## **TOWN OF BLUFFTON HISTORIC PRESERVATION COMMISSION**

### **ELECTRONIC MEETING**

Wednesday, February 3, 2021 6:00p.m.

<b>MEETING DATE:</b>	February 6, 2021
<b>PROJECT:</b>	114 Pritchard Street– Addition to Single-Family Residential
<b>APPLICANT:</b>	Ansley H. Manuel, Architect
<b>PROJECT MANAGER:</b>	Katie Peterson, AICP, Senior Planner

**A**  
**A4** PROPOSED EAST ELEVATION  
SCALE: 1/4"=1'-0" (FACES PRITCHARD STREET)

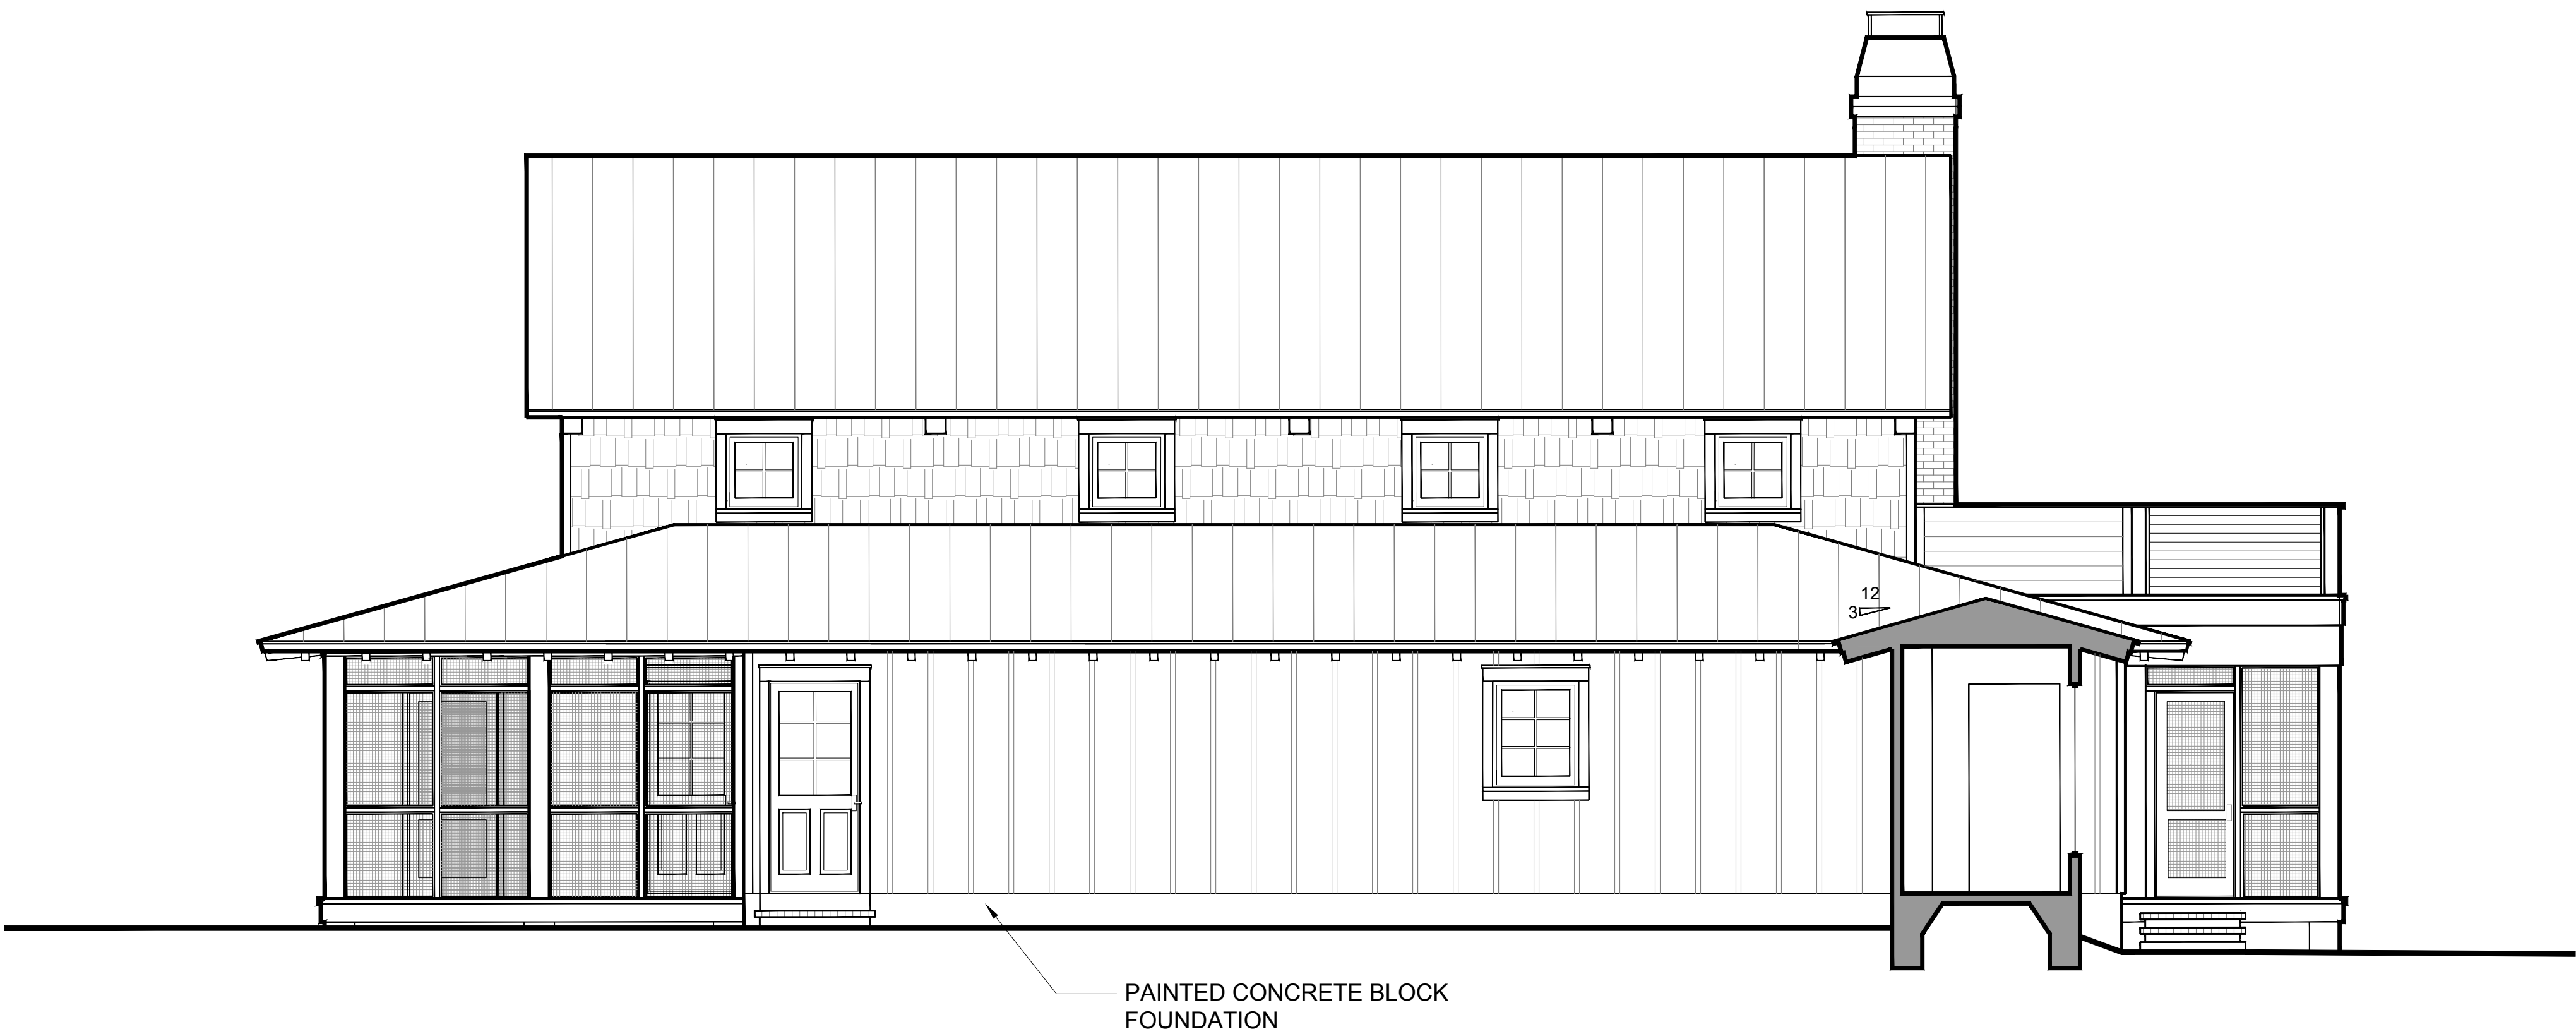
1. Windows are permitted to be square, rectangle, transom or sidelite. The plans propose a circular window on the east elevation and two right trapezoids on the west elevation. Windows must be revised to meet this requirement. (UDO 5.15.6.I.3.a.)

*Response to Proposed Circular Window:*

**A**  
**A5** PROPOSED WEST ELEVATION  
SCALE: 1/4"=1'-0" (FACES HEYWARD COVE)

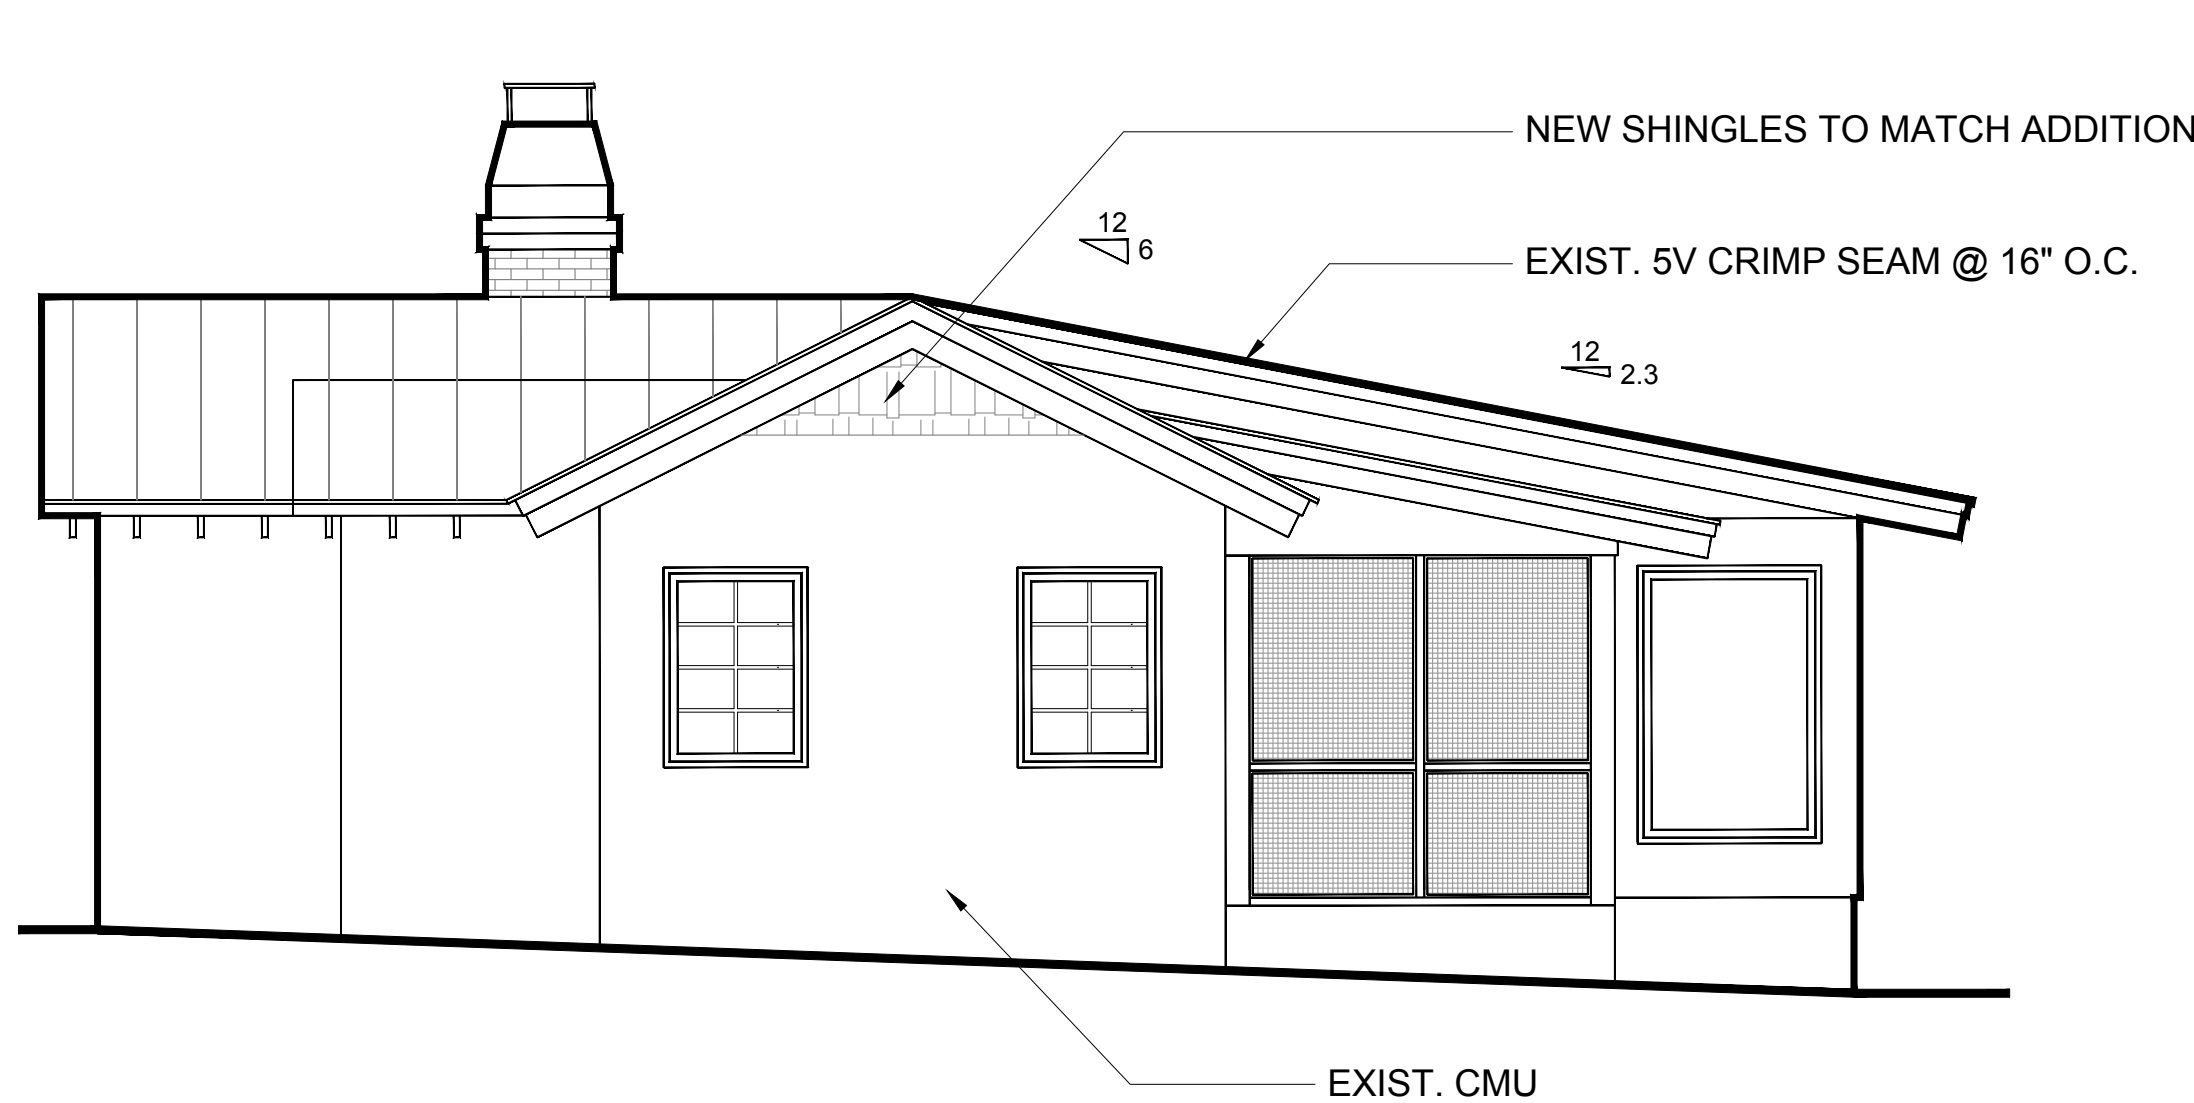
2.The UDO requires that porch posts shall be spaced no farther apart than they are tall. Columns are proposed as further apart on center than they are tall on the west elevation. The column placement must be revised to meet this requirement. (UDO5.15.6.H.1.a. and Traditional Construction Patterns Section 52)

11. Railings are permitted to be wood (termite resistant), painted or natural wrought or cast iron. The plans note the use of cable railings on the second story balcony on the west elevation. Railings must be revised to meet this standard. (UDO 5.15.6.H.2.d.)

*Okay - We have added an additional column as recommended by the Review Team*

*Response:*

*We would ask the review board to please consider allowing the use of Stainless Steel Cable Railing on the second story balcony on the west elevation facing Heyward Cove. The balcony is in the plan as an open deck to be for observation of wildlife and to enjoy the cove. A cable railing offers the least obstruction to the view and has been used on other recent projects in Bluffton. The most recent example is on the Cunningham Residence, located just one cove down from Heyward Cove. Again, the cove/west side of the house cannot be seen from any street.*

B  
A9 HANDRAIL DETAIL (TYPICAL)  
SCALE: 3"=1'-0"

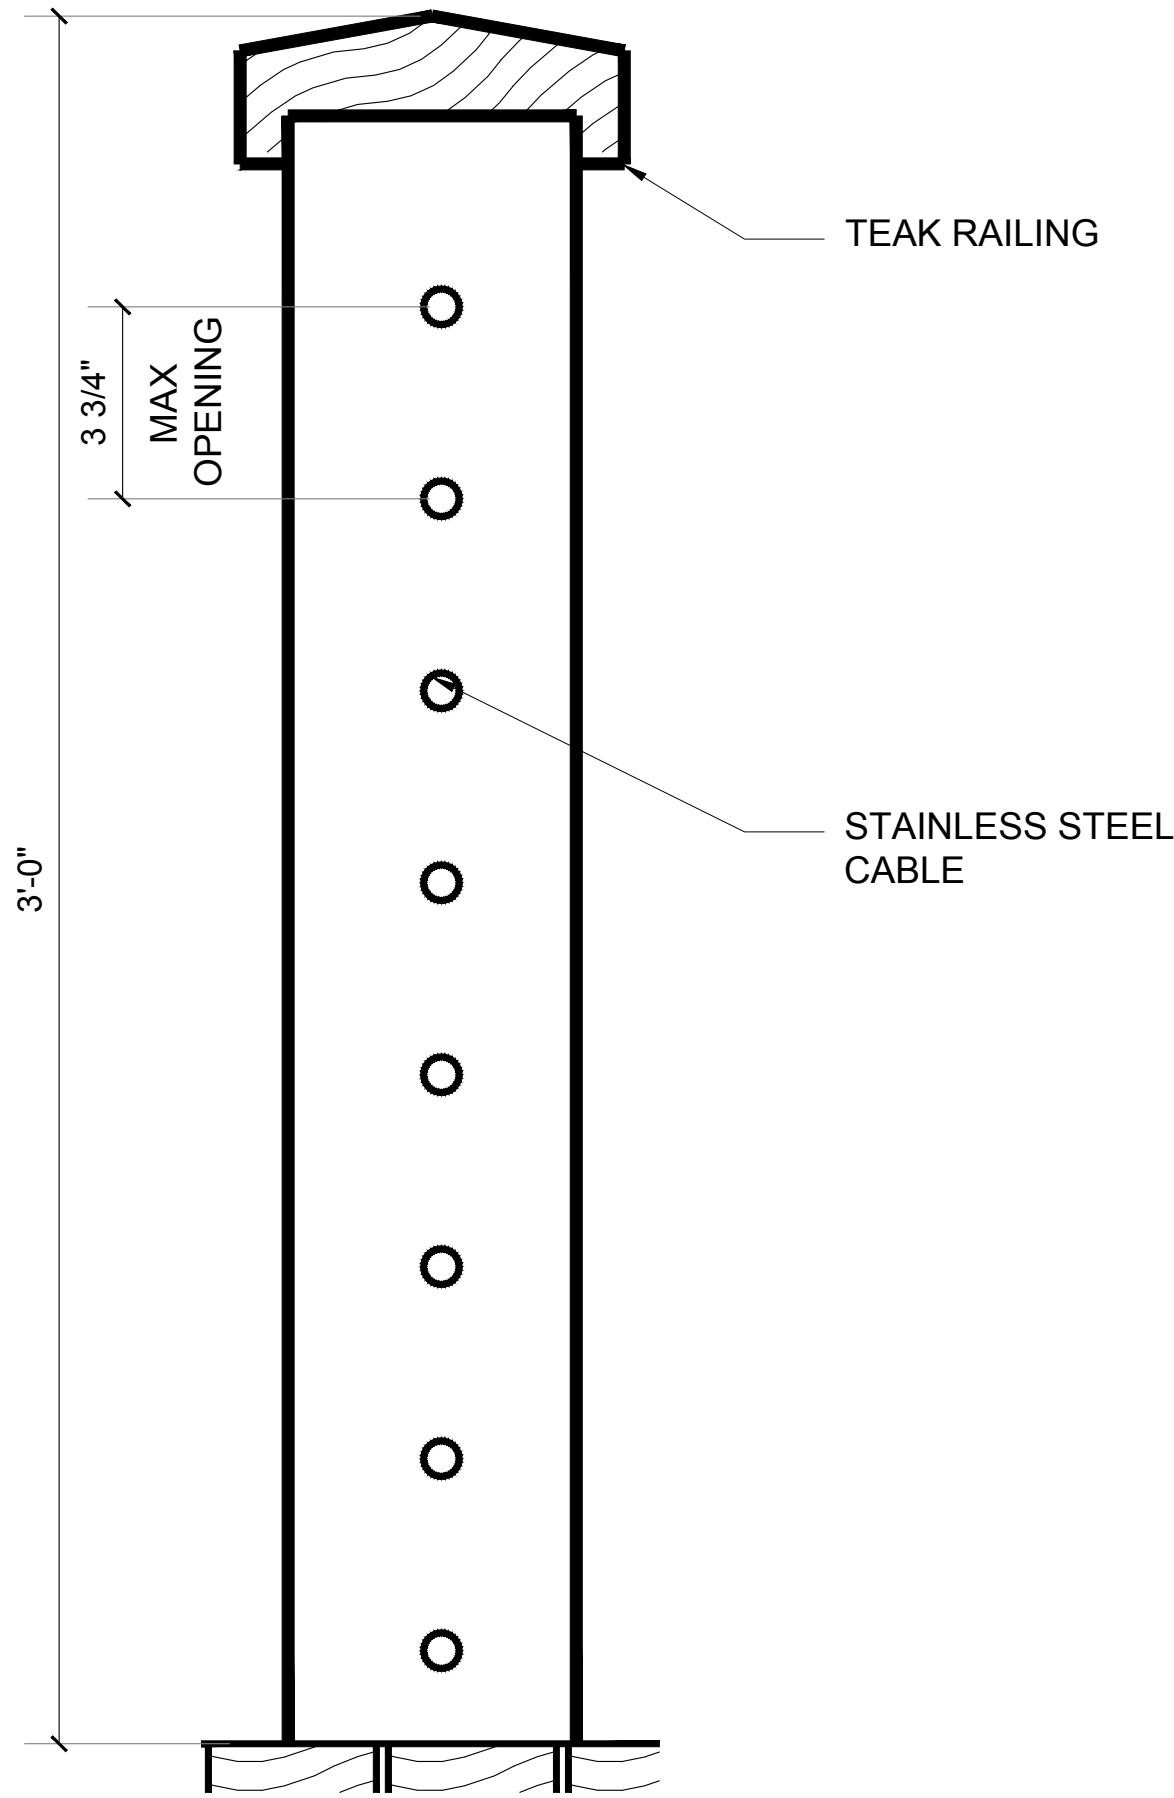
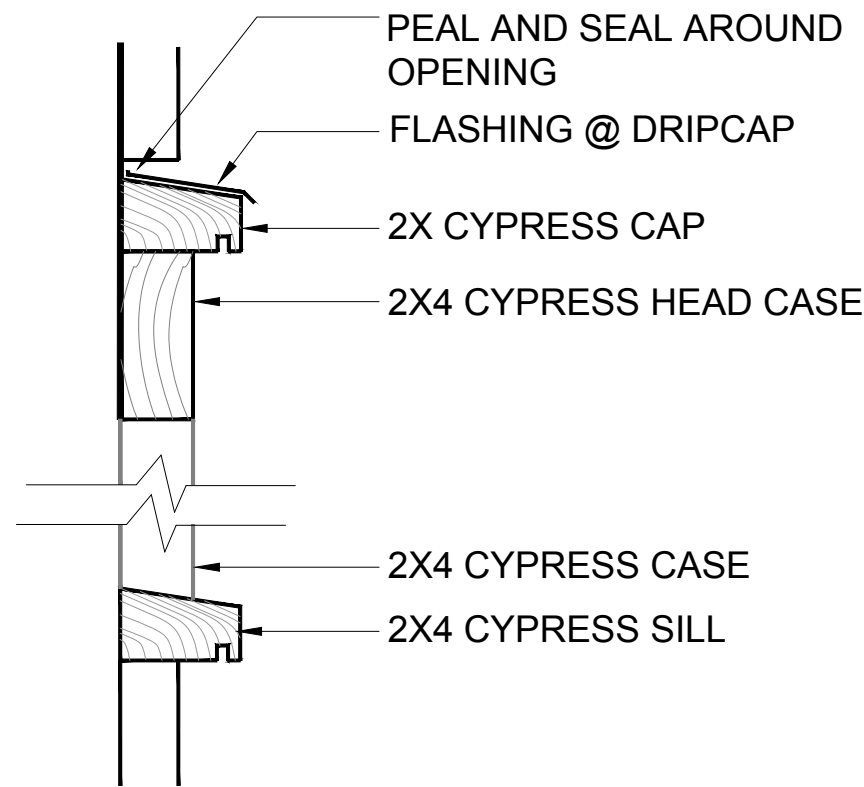
- 2) Section 5.15.6.H.2.d. Columns, Arches, Piers, Railings, Balustrades. Railings and balusters are permitted to be Wood (termite resistant), painted or natural Wrought or Cast Iron. Detail B on page A9 notes the railing section to have a teak handrail with stainless steel cable. The Applicant is requesting the HPC allow the use of this material as a substitute material for those listed as options under the Architectural Standards as permitted by Section 5.15.6.A. of the UDO.
